AS-BUILT PLAN REVISIONS
BY Roy A. Galli DATE 12-18-89
RCE 16024
ADD LOC DIMS FOR 8 MILE AND
QUASHNICK RD ON 18" S.D. INLET DET.
ADDED SHEETS 28A & 28B

MORADA ESTATES NORTH
SAN JOAQUIN COUNTY

STREET IMPROVEMENT PLANS: MORADA ESTATES NORTH

NORTH MORADA ESTATES
MASONRY WALL PLAN

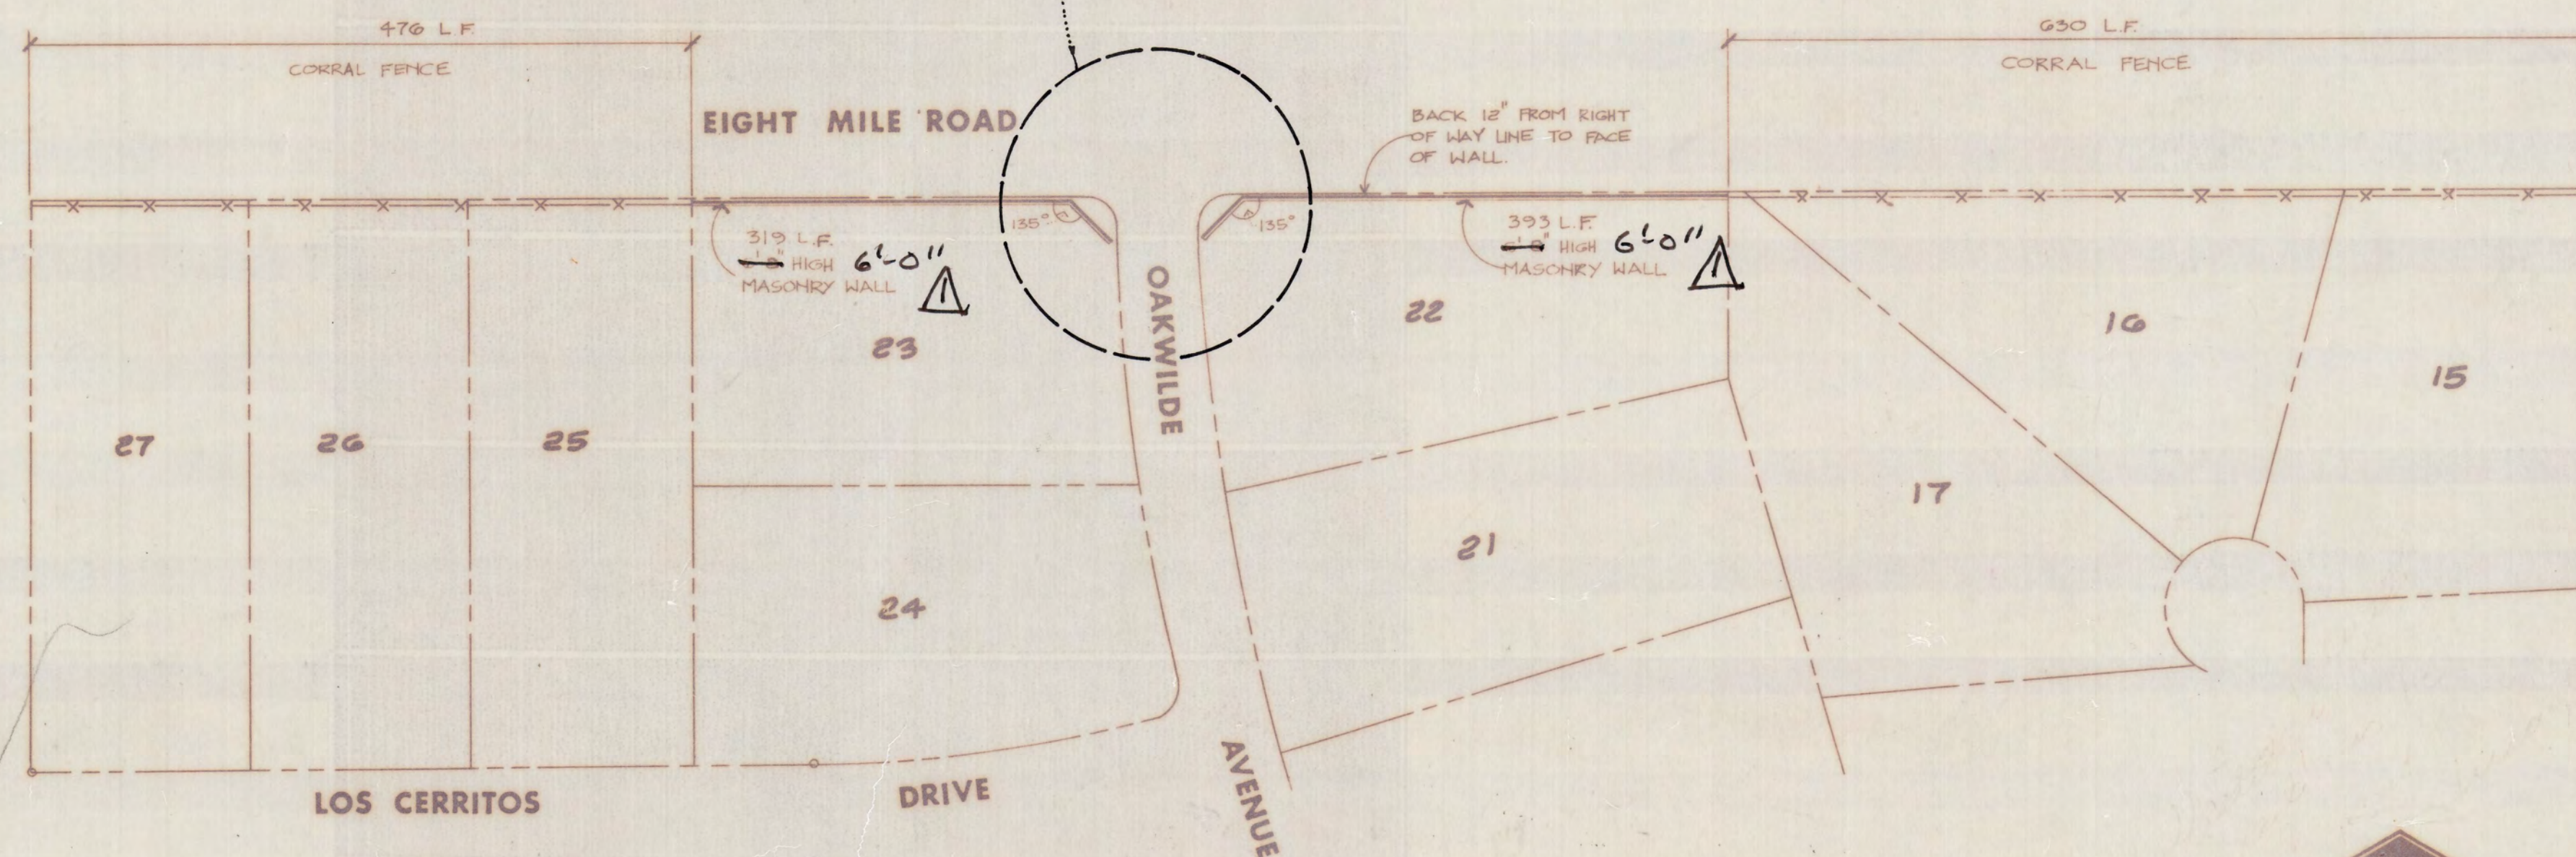
"As Built" Plans
by Roy A. Galli date: 12-18-89
RCE16024
Δ wall @ 6'-0" (reduced to 6'-0" from 6'-8")

WELL PROFILES AND DETAILS
MORADA ESTATES NORTH
SAN JOAQUIN COUNTY

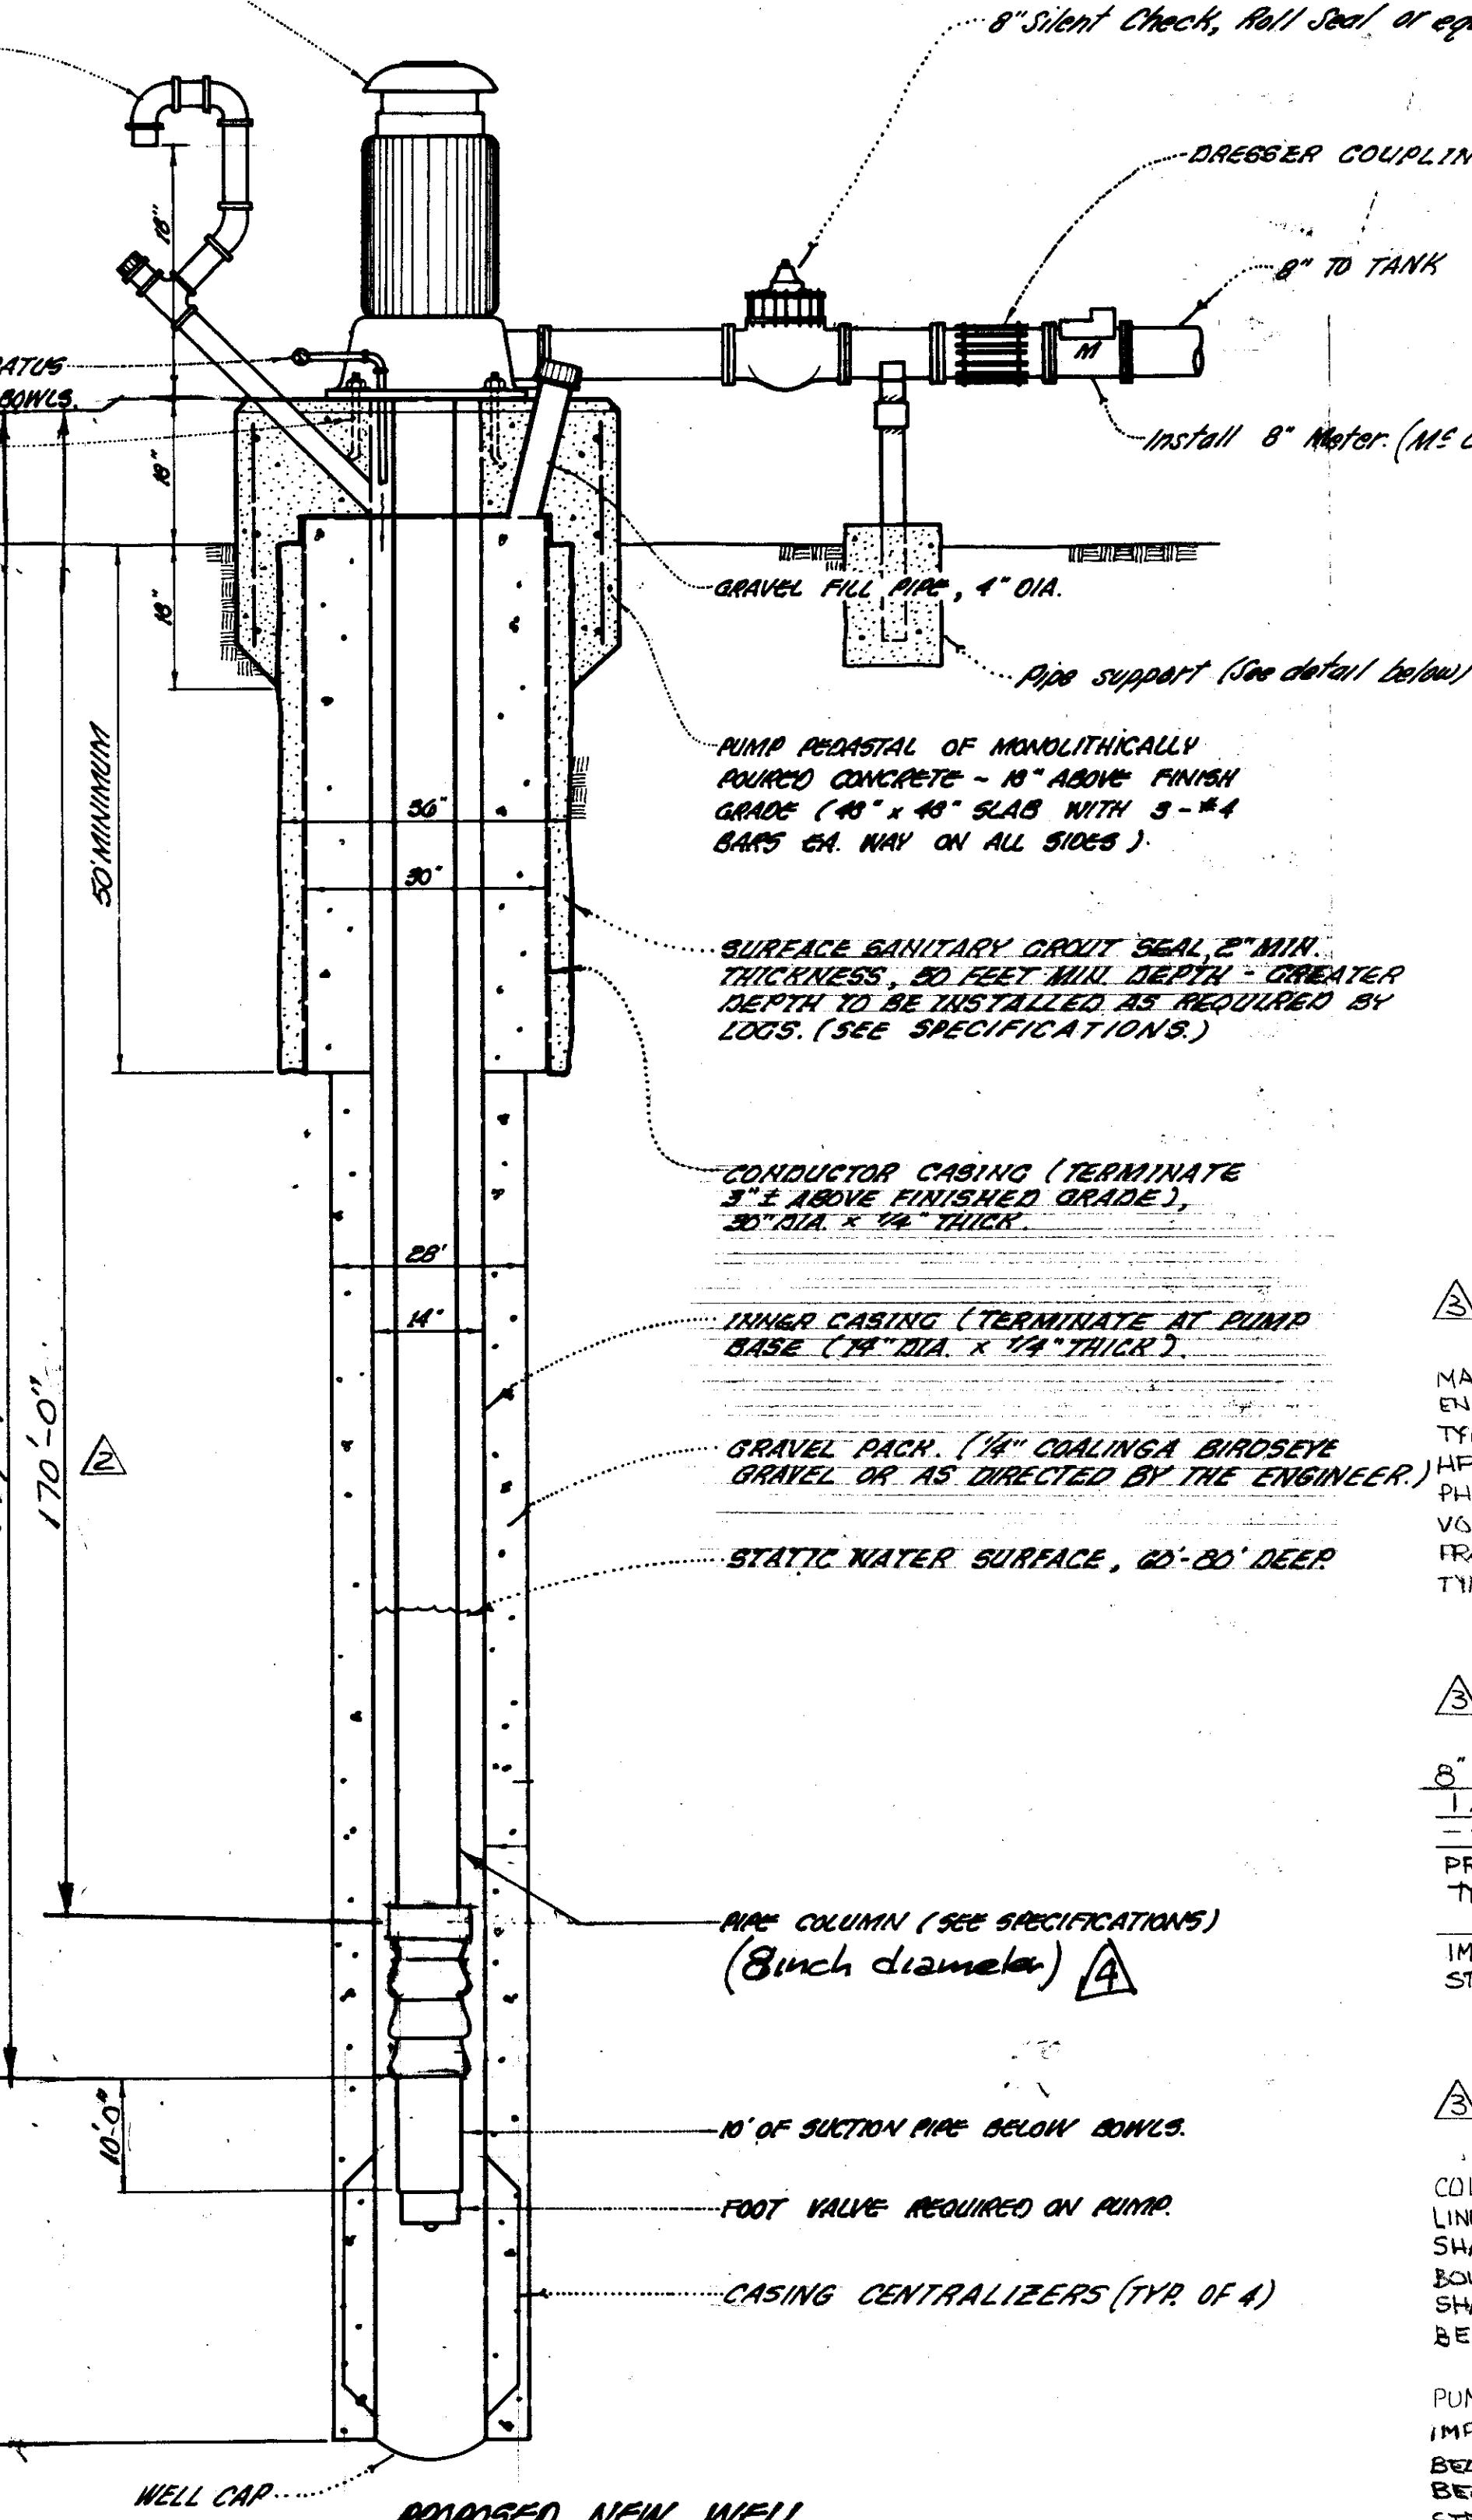
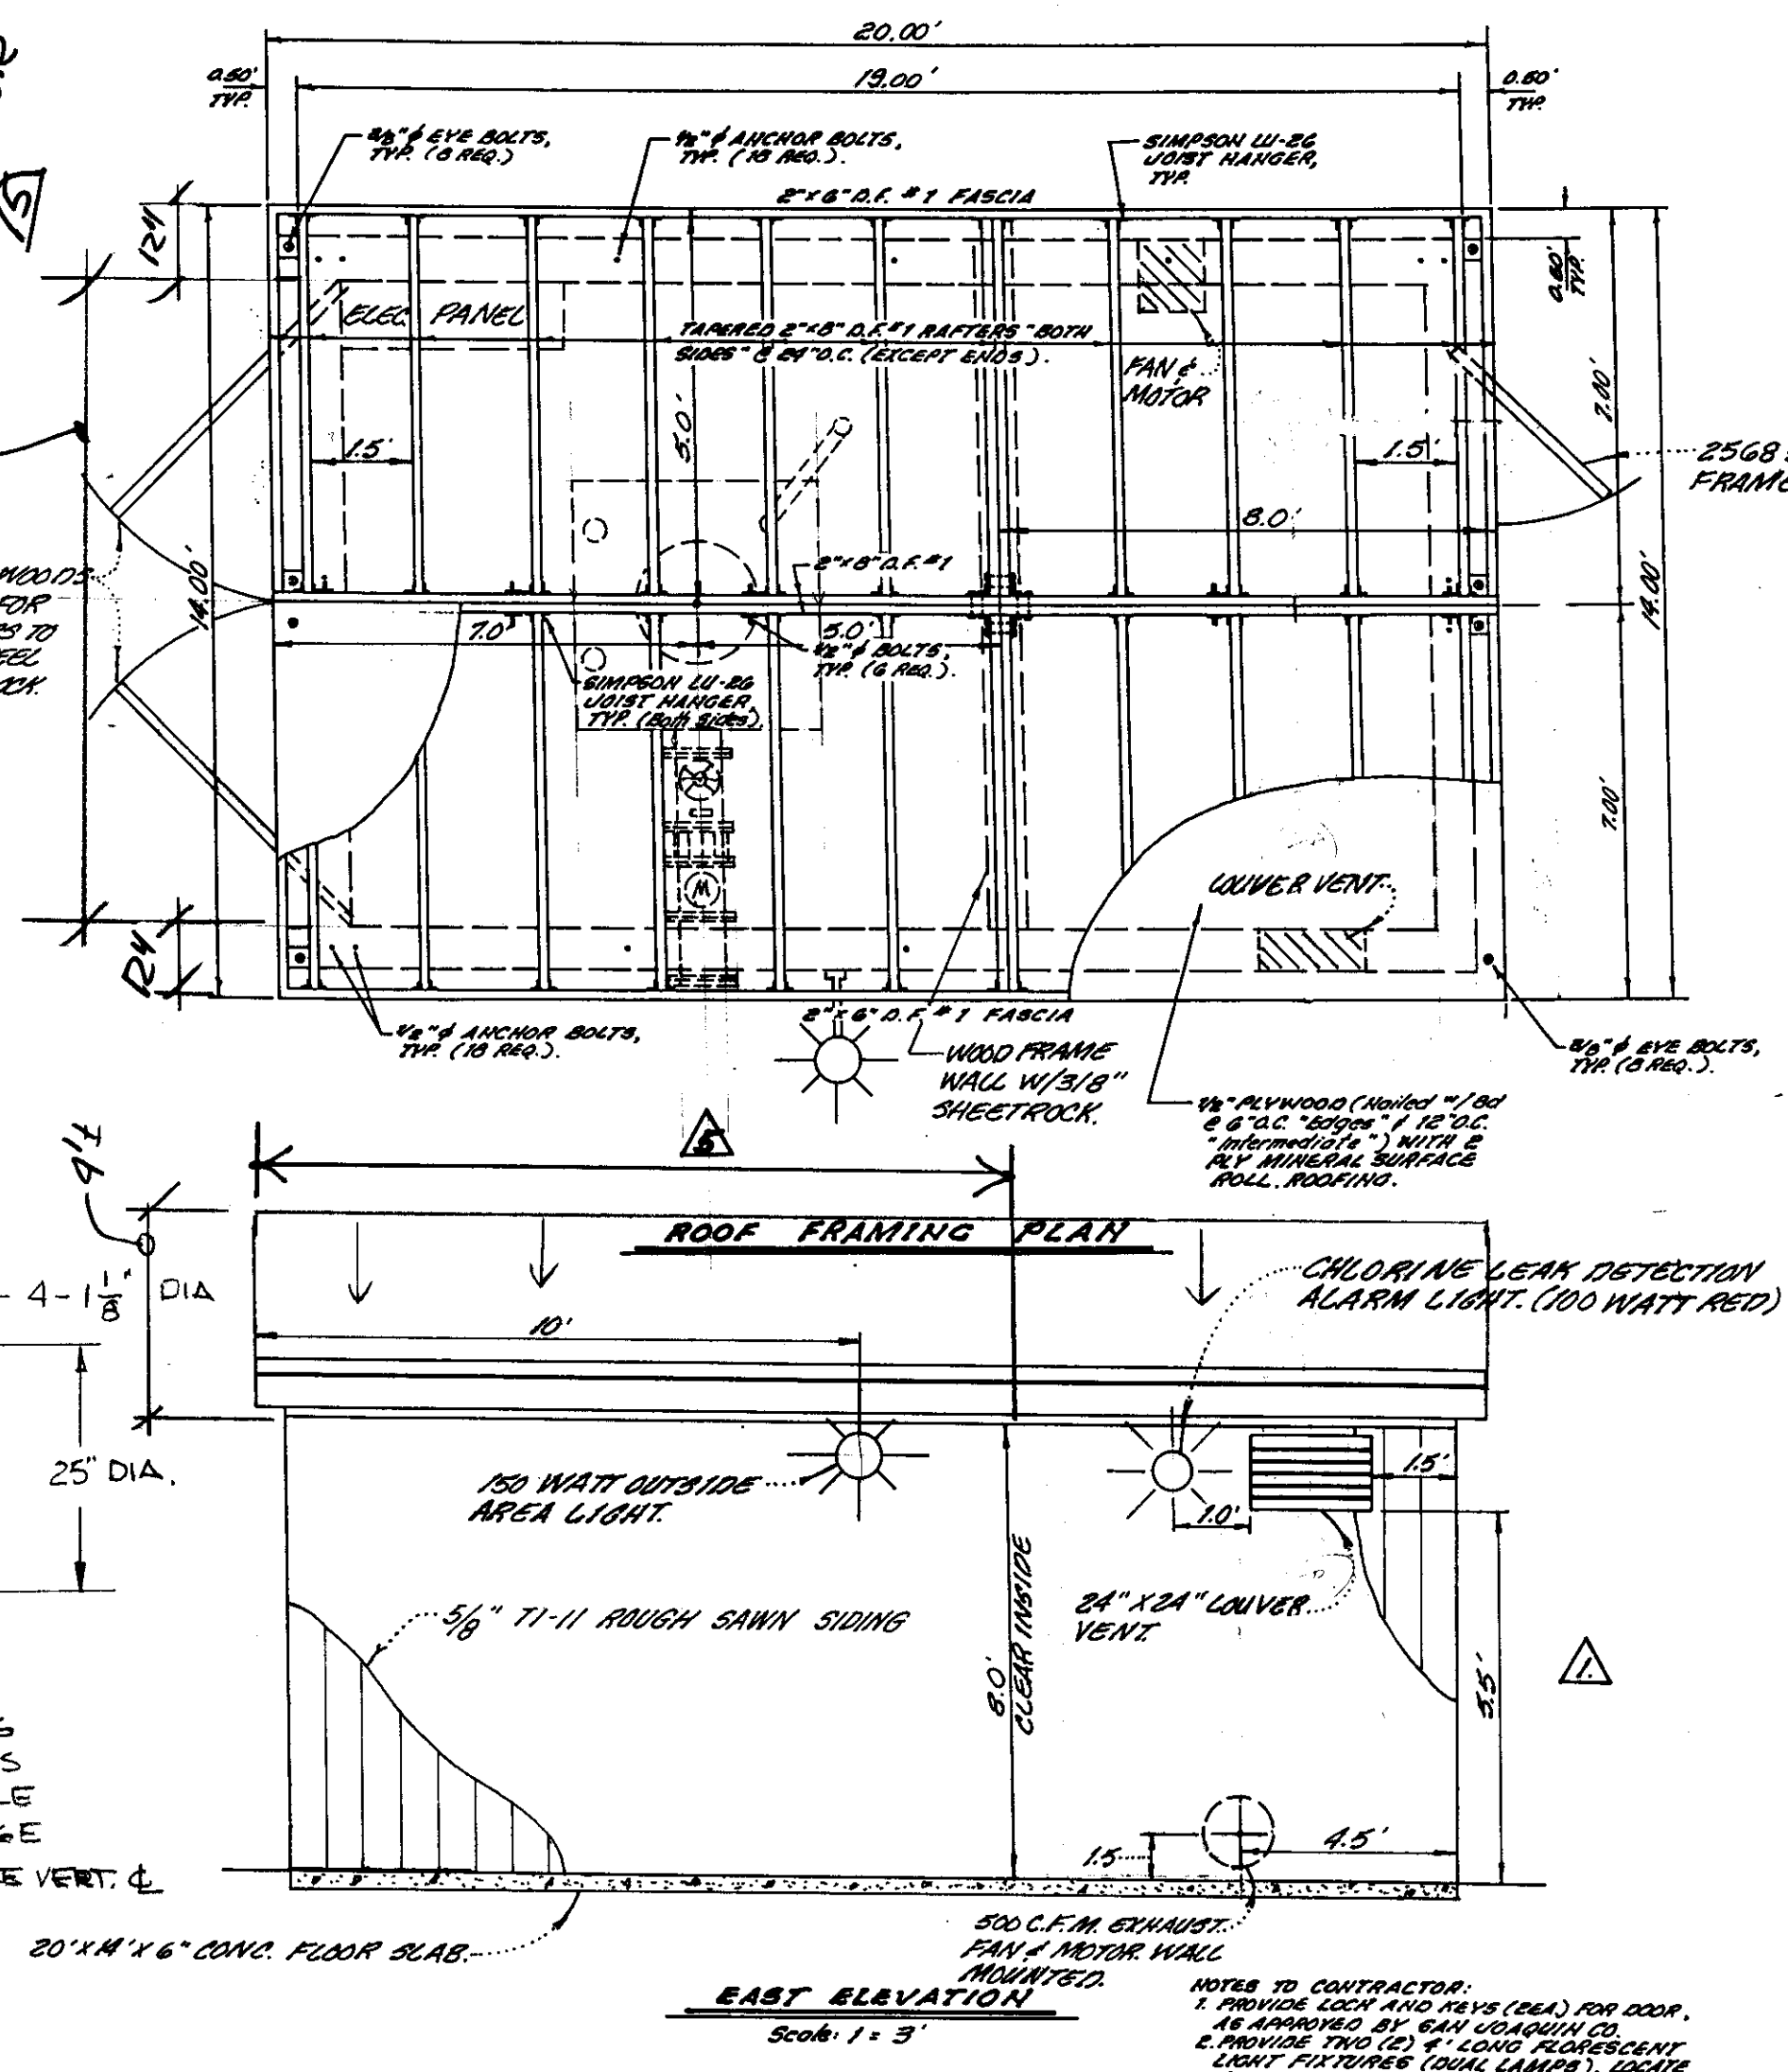
- AS BUILT PLAN REVISIONS
BY Lou H. Allen DATE 12-18-89
RCE 16024
- REVIS WELL PROFILE DIMS
 - ADD PUMP & MOTOR SPECS
 - WELL DEPTHS & PIPE CO. SIZE
 - Removable roof section & photo
